**ADDENDUM NO. ONE (1)**

**PROJECT NO: 128696**  
**TITLE OF PROJECT: Flood Repairs**  
**FACILITY NAME: CF Dickinson Marine Laboratory**  
**LOCATION: Galveston County, Texas**

## AMENDMENT NUMBER 01

Amendment Dated 05/31/2018

**1 LAB POWER PLAN**  
EP211-B 1/8"=1'-0"

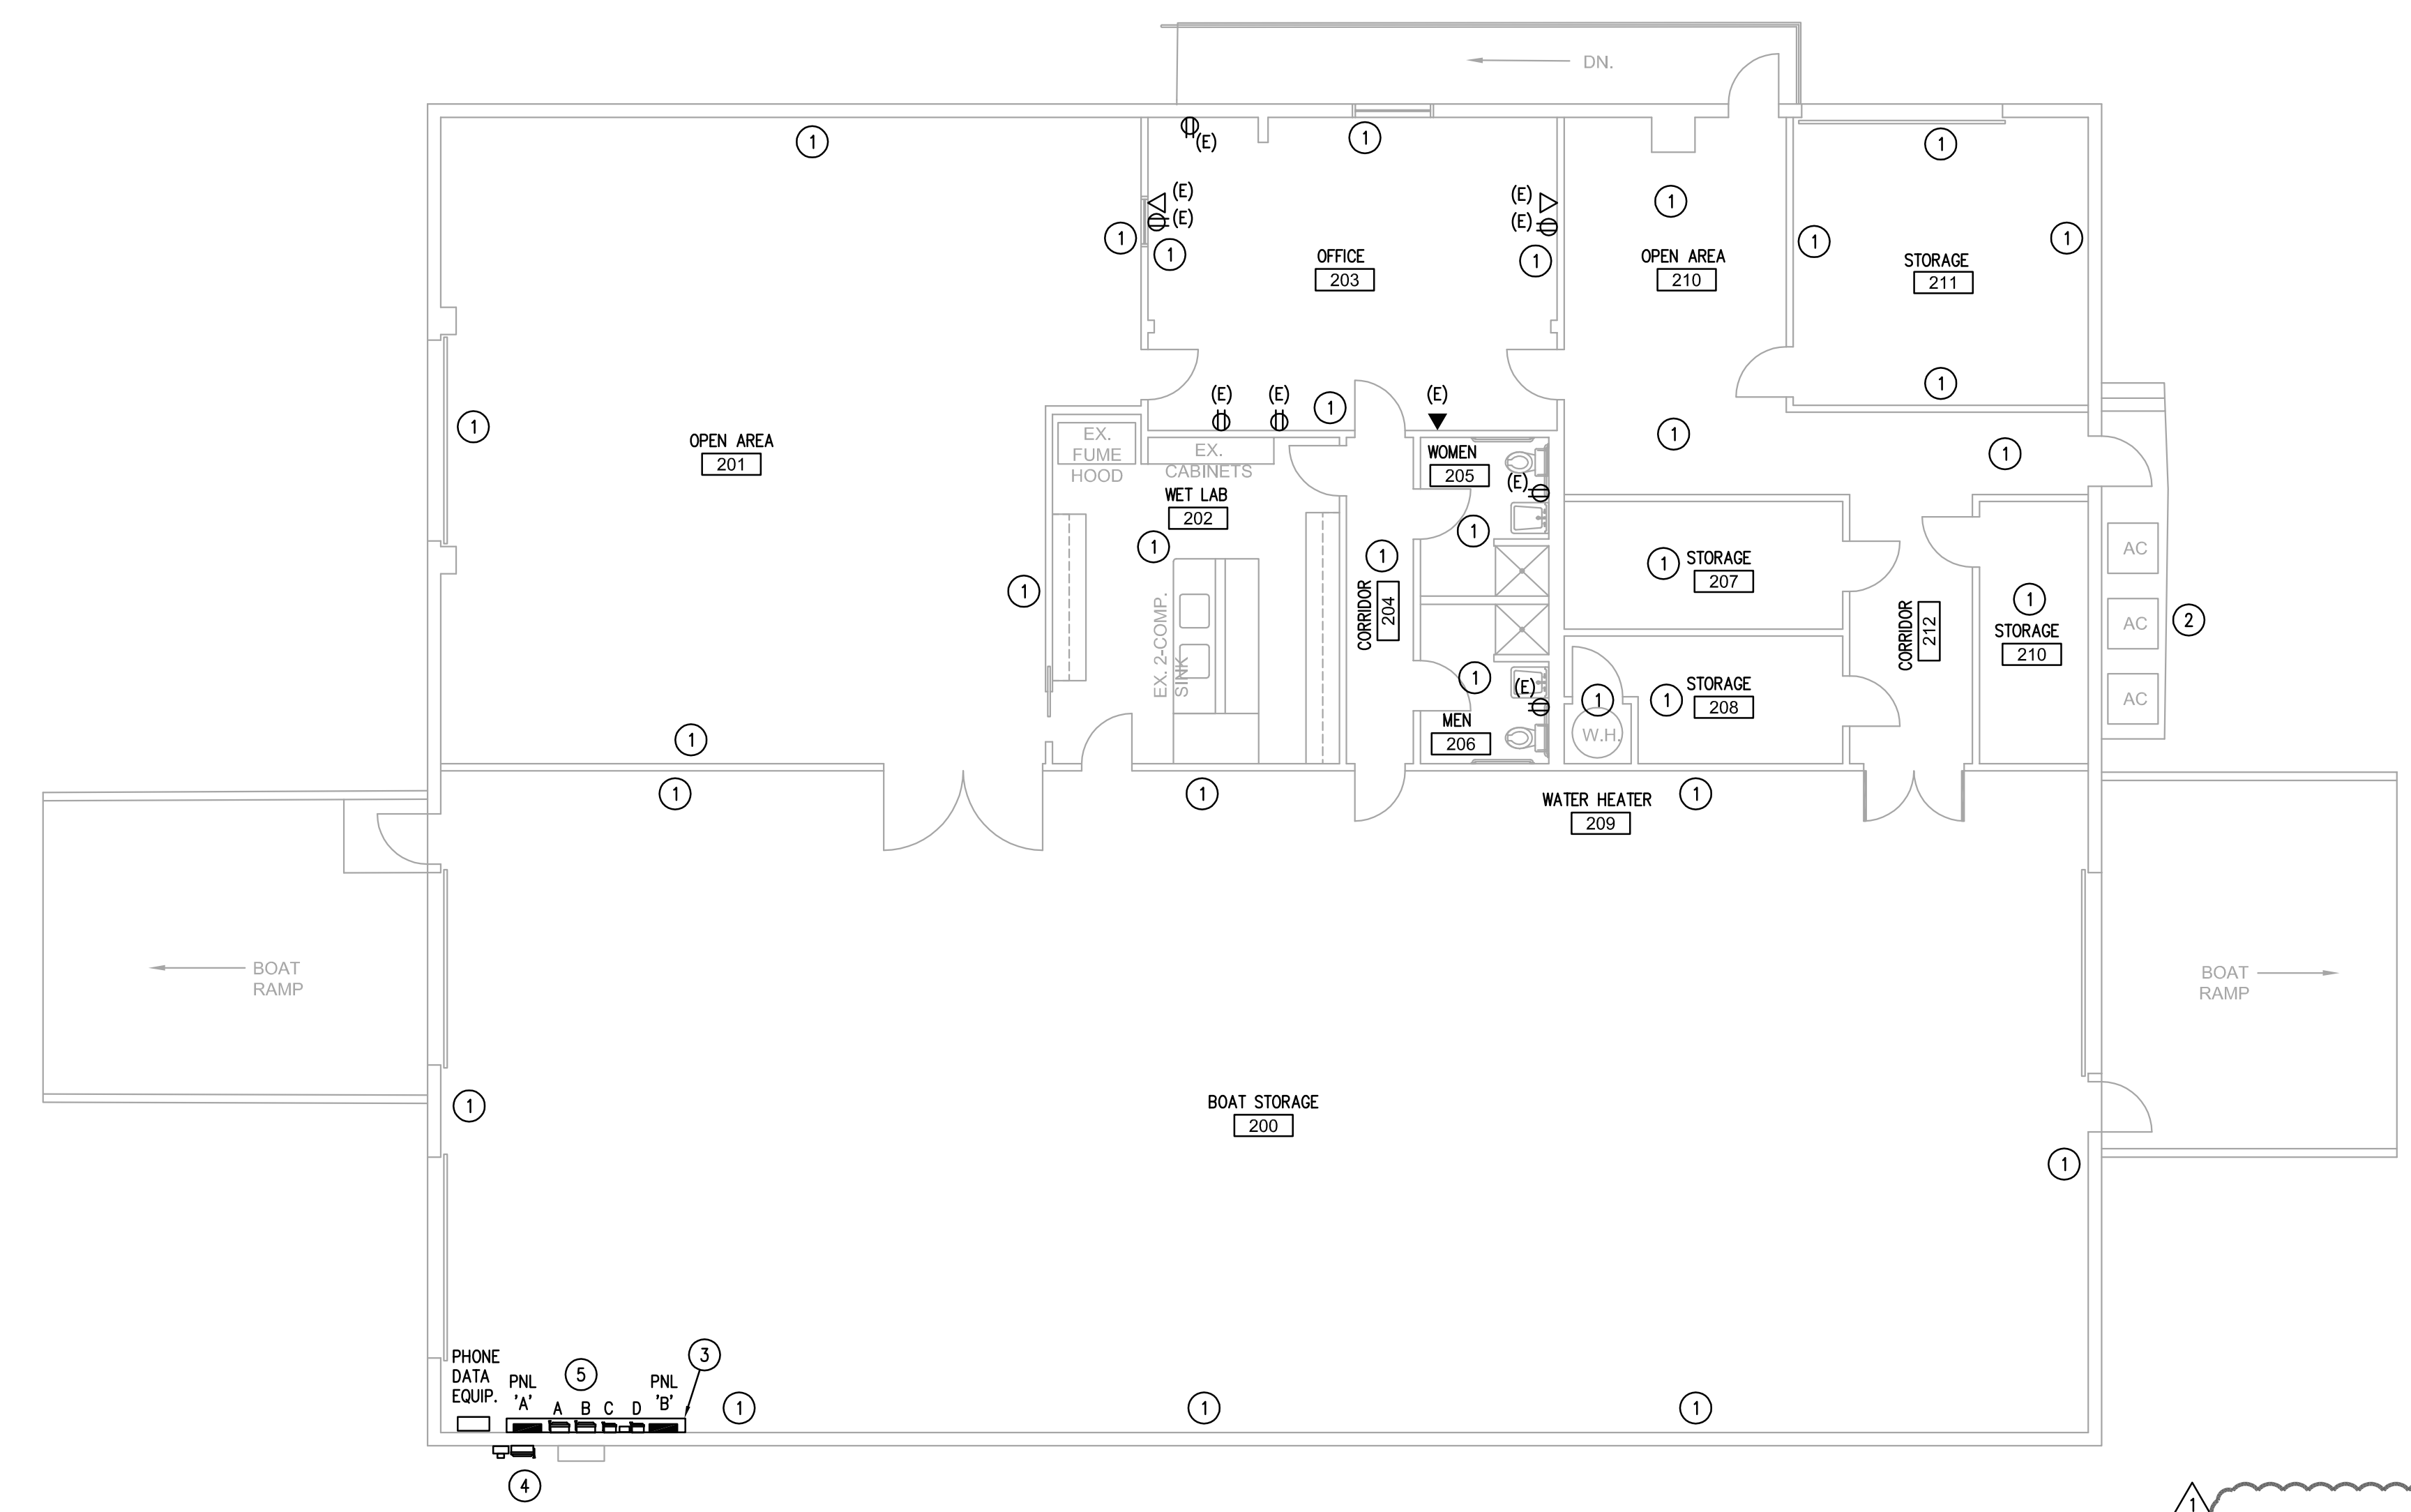
3. EXISTING ELECTRICAL 400 AMPS 120/240V/3PH/4W ELECTRICAL SERVICE GUTTER MOUNTED VERY LOW CLOSE TO FLOOR. ELECTRICAL CONTRACTOR SHALL FIELD OPEN WIREWAY AND SEE AND CHECK WIRING/BUSSING AND VERIFY THAT THERE IS NO WATER FLOOD DAMAGE. REFURBISH GUTTER AS REQUIRED IF DAMAGED DETECTED.

4. EXISTING 400A, NEMA3R SERVICE ENTRANCE MAIN DISCONNECT SWITCH HEAVILY RUSTED AT BOTTOM AND A KNOCKOUT BUSTED CREATING A ELECTROCUTTING HAZARD. ELECTRICAL CONTRACTOR SHALL DISCONNECT REMOVE AND REPLACE.

**1 LEVEL 1 POWER PLAN**  
EP101 1/8" = 1'-0"

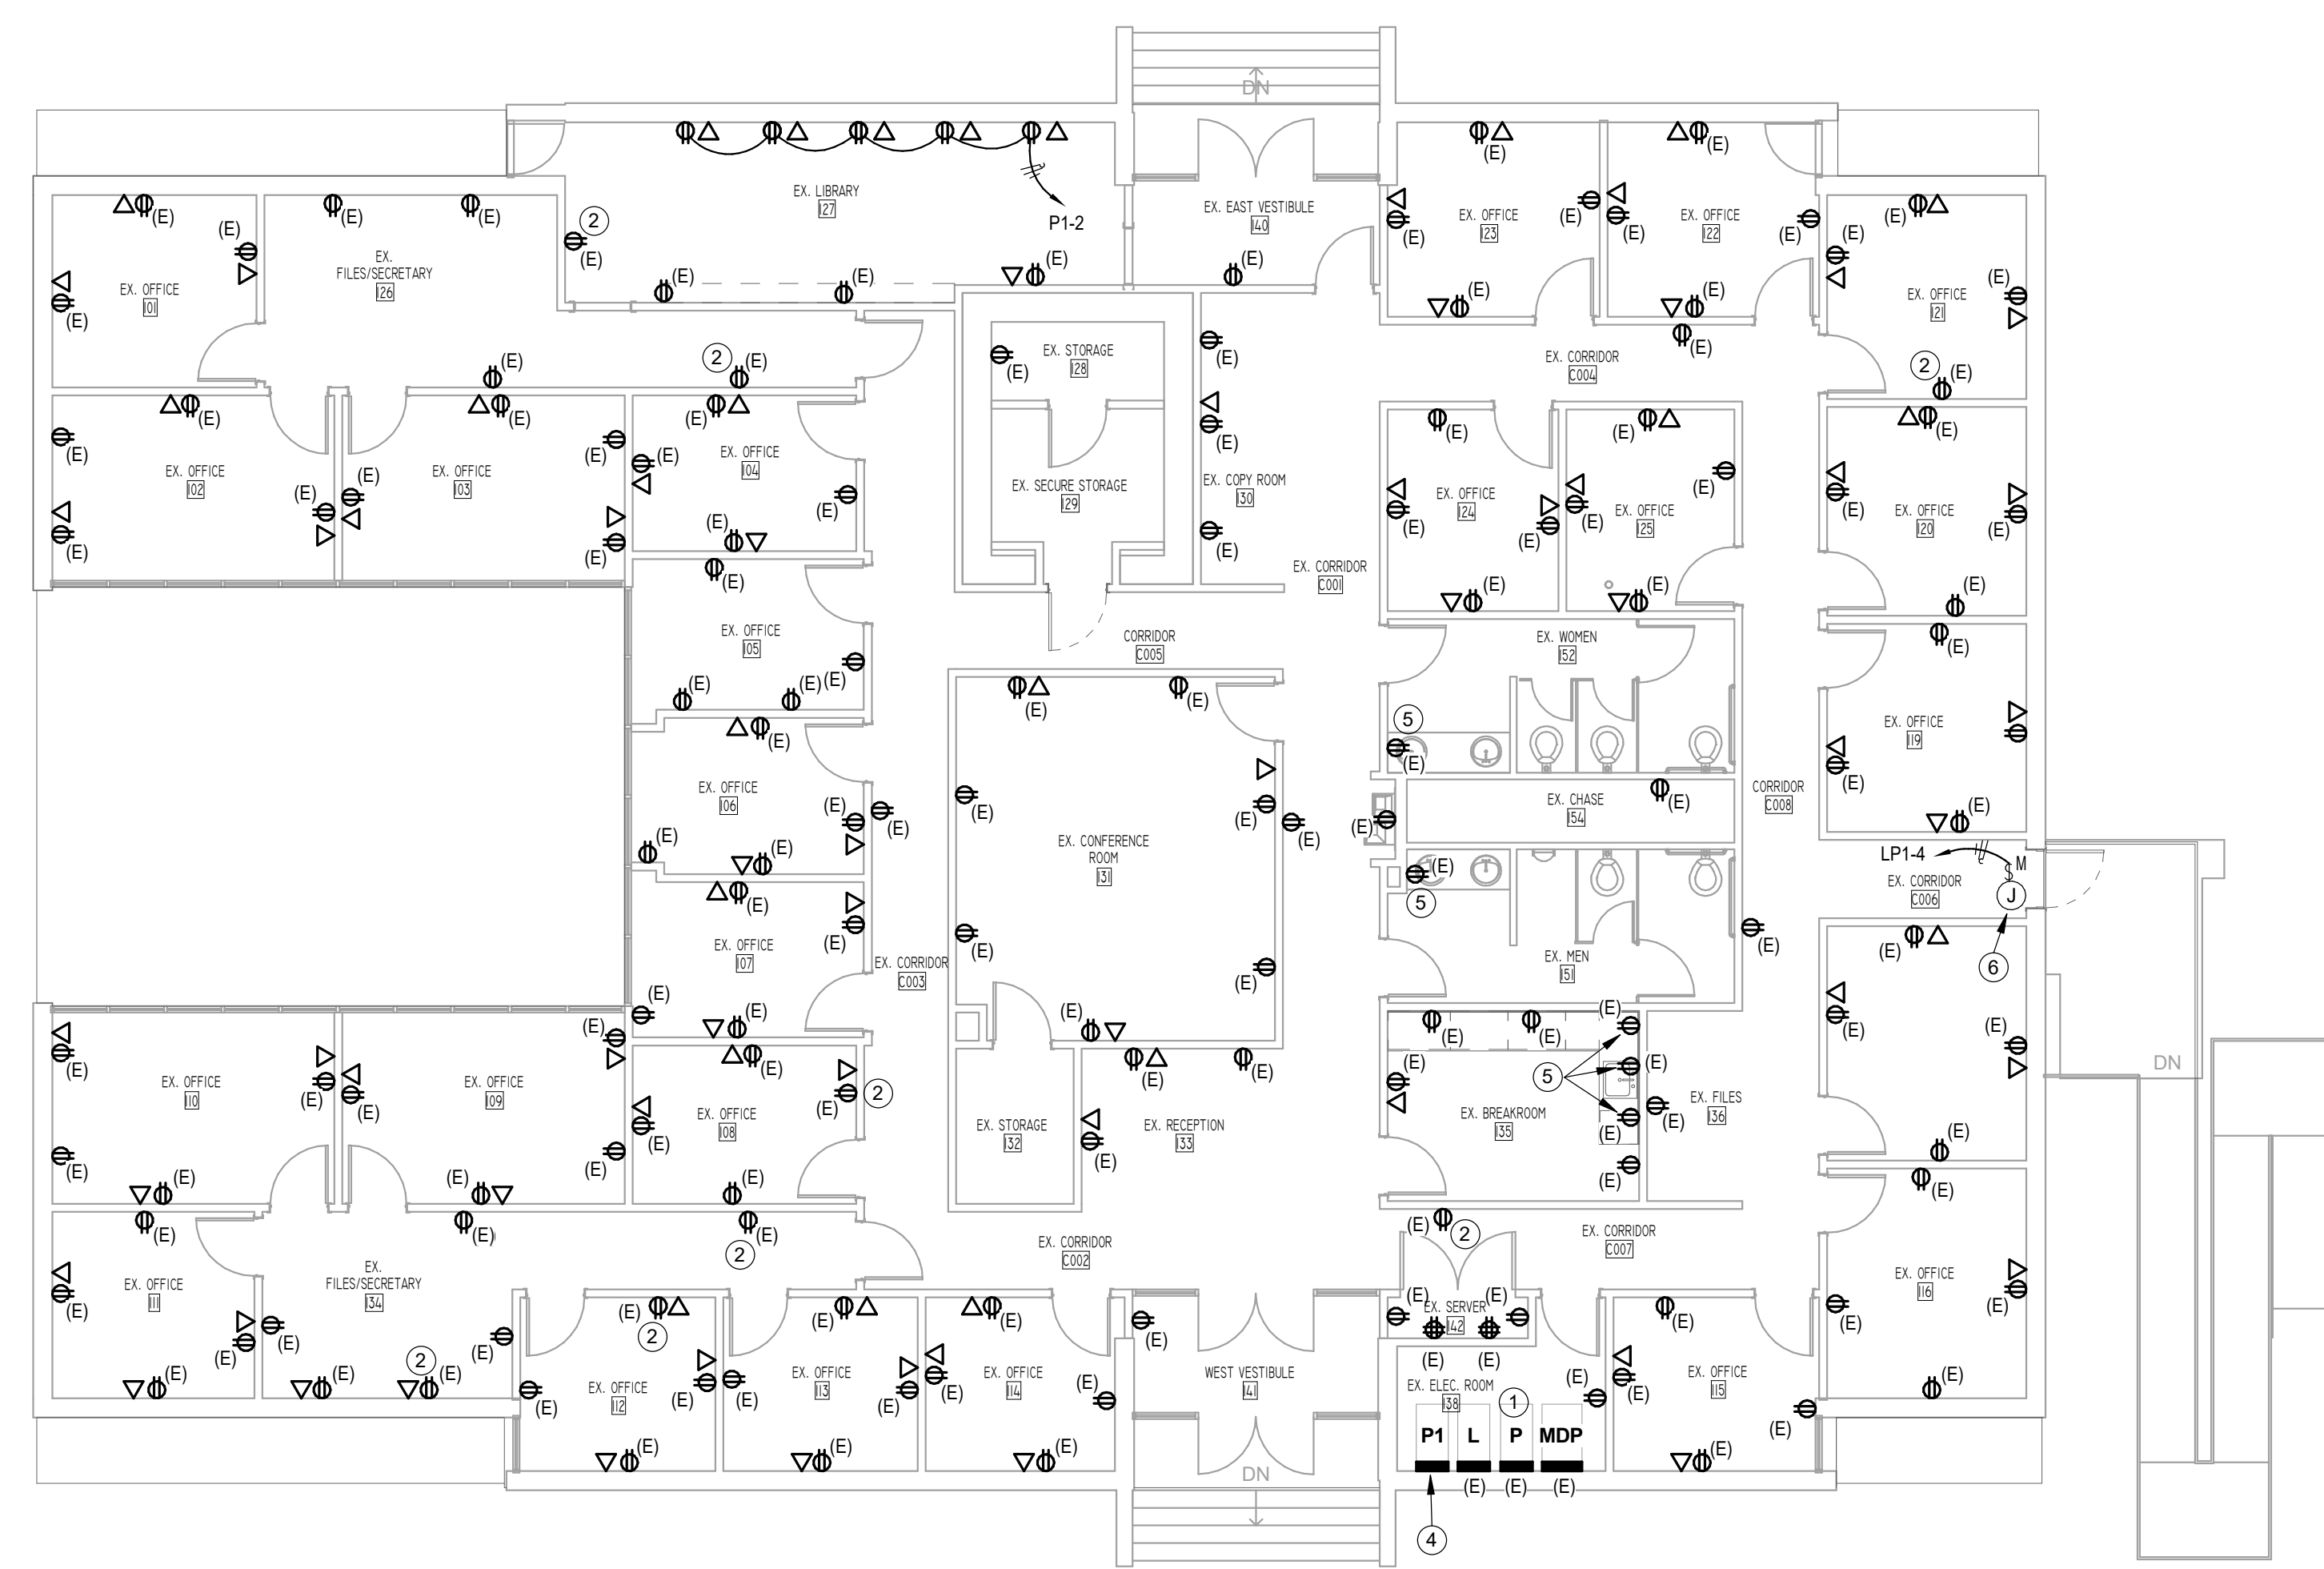
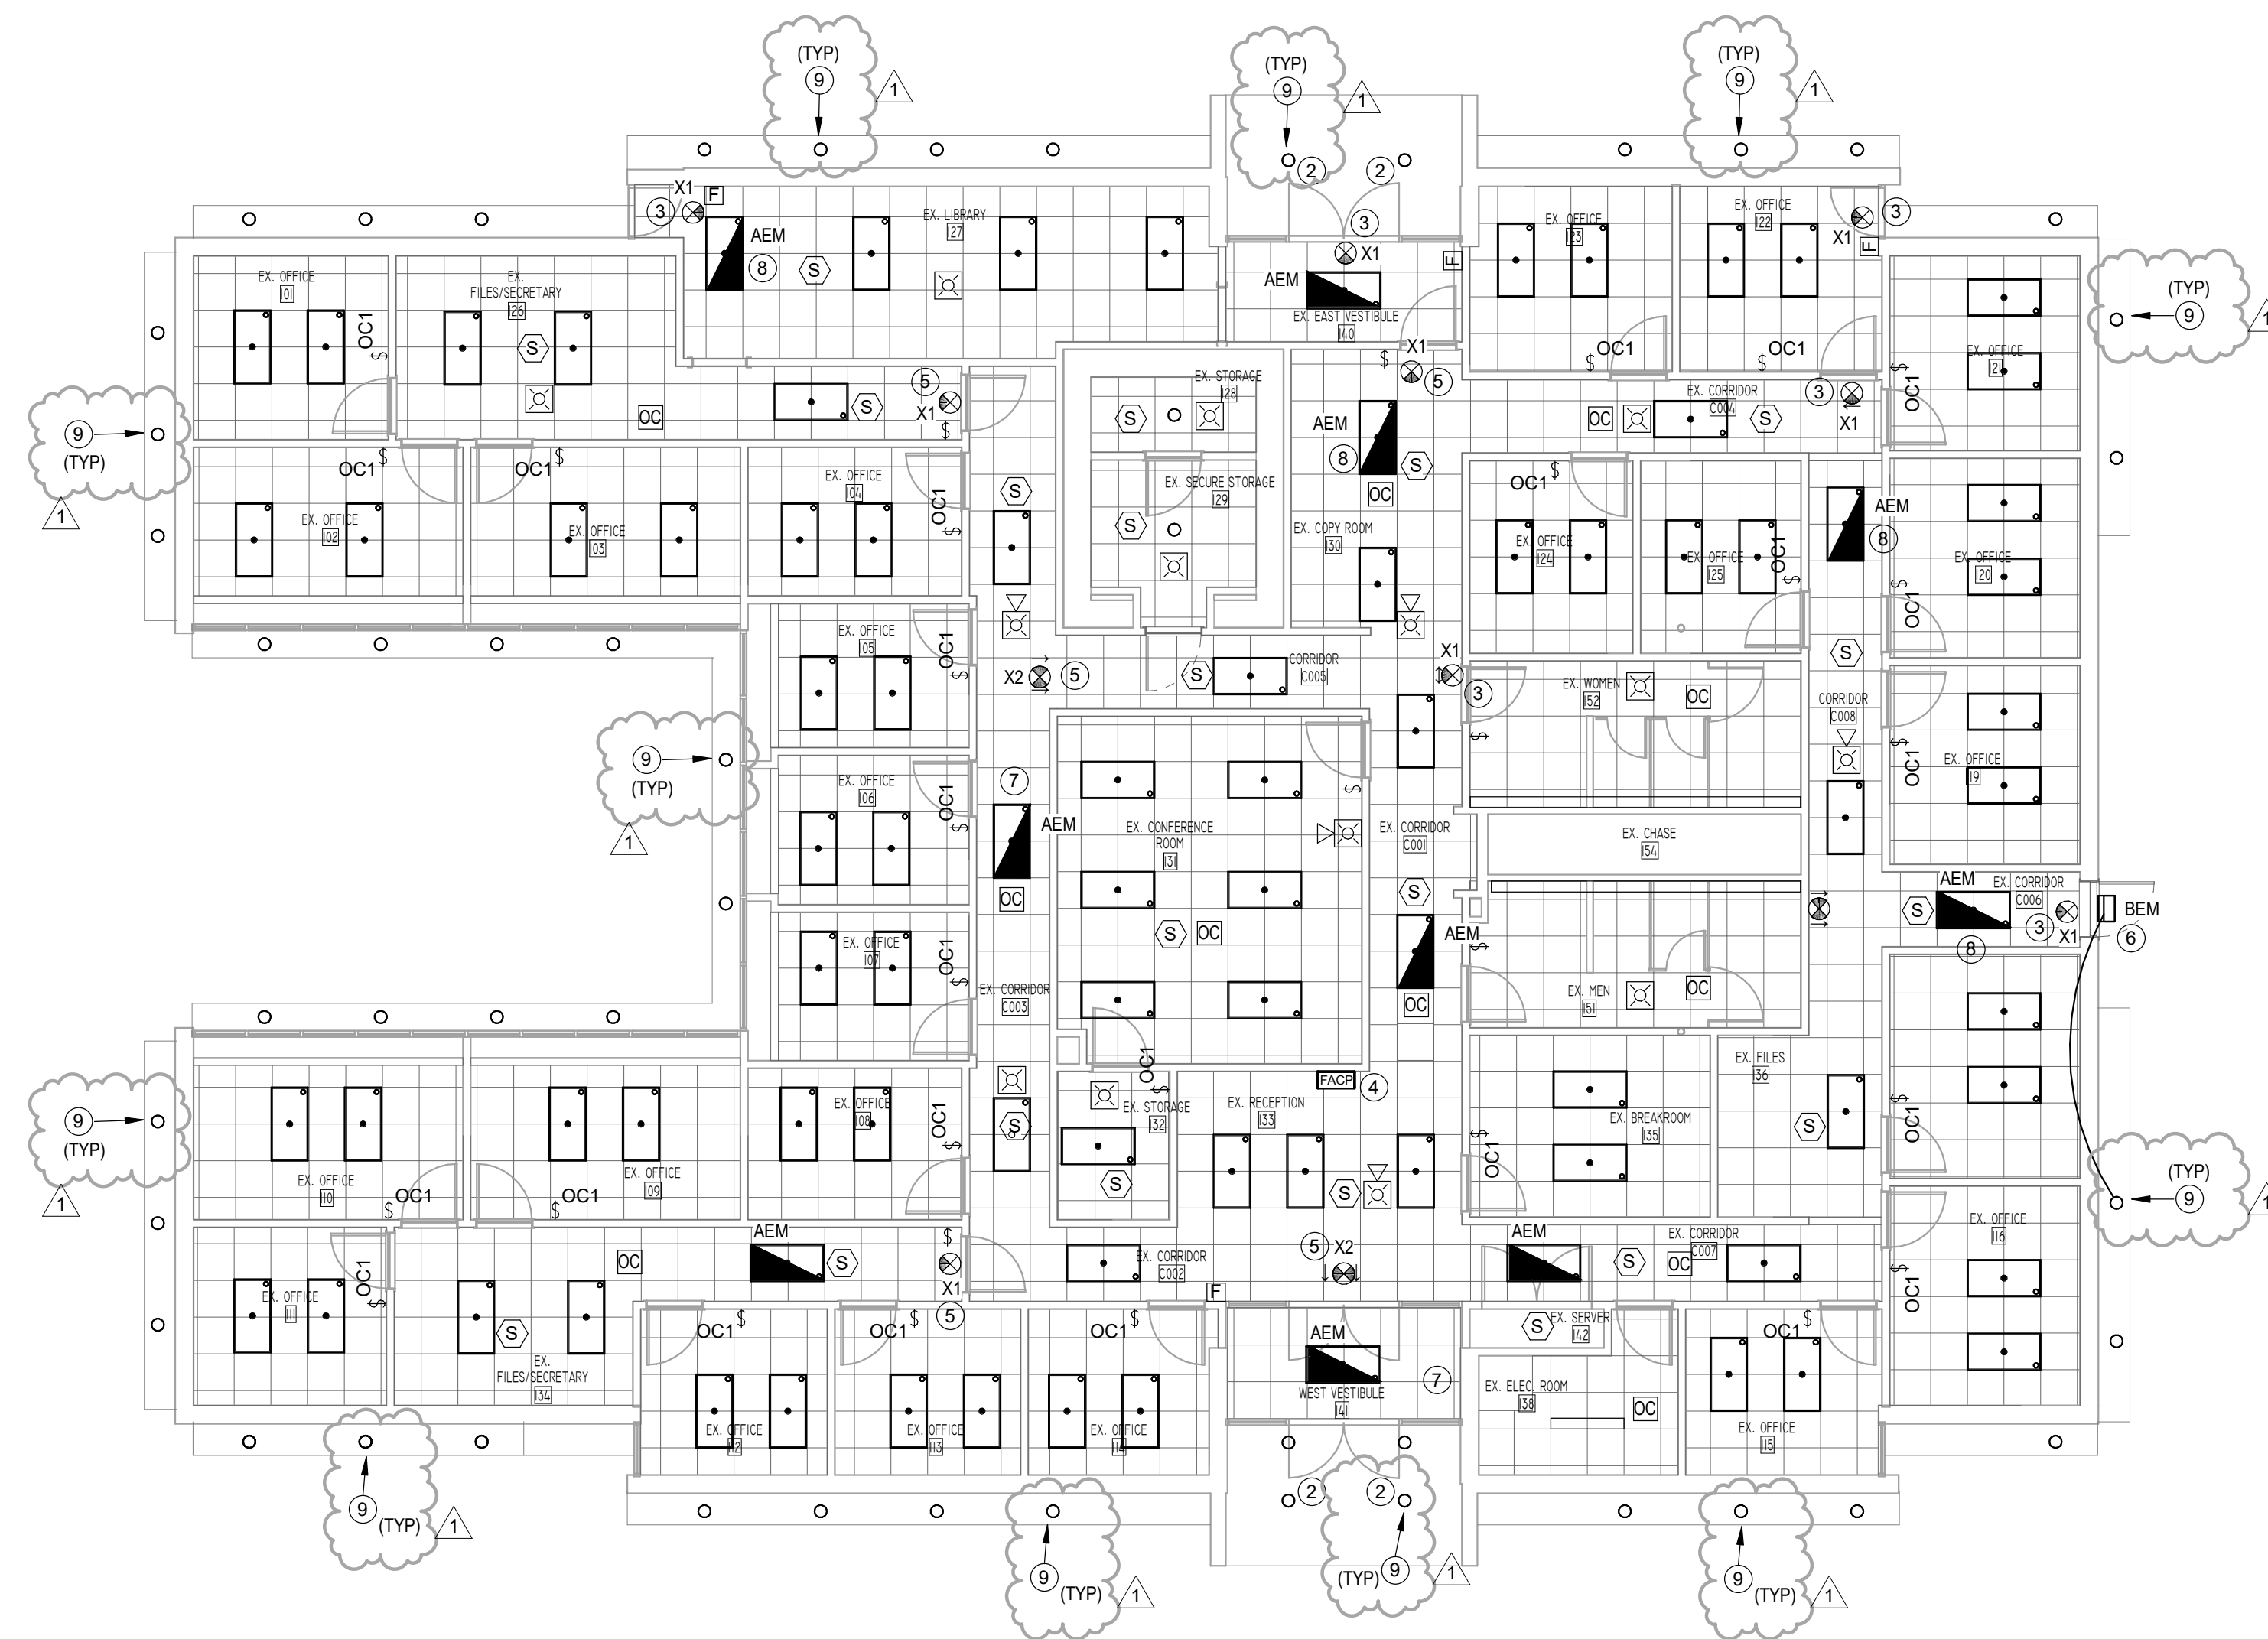
- 1 EXISTING ELECTRICAL EQUIPMENT GEAR TO REMAIN.
- 2 ELECTRICAL CONTRACTOR SHALL REPLACE BROKEN RECEPTACLE COVER PLATE. REFER TO THE ELECTRICAL DEMOLITION NOTES FOR ADDITIONAL INFORMATION.
- 3 NOT USED.
- 4 NEW 120/240V POWER PANEL REFER TO ONE LINE DIAGRAM #1/301. ELECTRICAL CONTRACTOR SHALL COORDINATE LOCATION WITH EXISTING EQUIPMENT TO COMPLY WITH NEC 2017 WORKING CLEARANCE.
- 5 ELECTRICAL CONTRACTOR SHALL FIELD COORDINATE AND ENSURE THAT THIS EXISTING RECEPTACLES BE "GFCI" RATED AND HAVE STAINLESS STEEL COVER PLATES. IF NOT THEN PROVIDE AND WIRE NEW "GFCI" WITH SS COVER PLATE RECEPTACLES.
- 6 JUNCTION BOX FOR ELECTRIC OPERATED DOOR OPENER. ELECTRICAL CONTRACTOR SHALL COORDINATE WITH DOOR OPENER MANUFACTURER FOR EXACT REQUIREMENTS PRIOR TO ROUGH-IN. PROVIDE ALL ACCESSORIES, LOW VOLTAGE WIRING AND PARTS AS REQUIRED FOR A COMPLETE INSTALLATION.
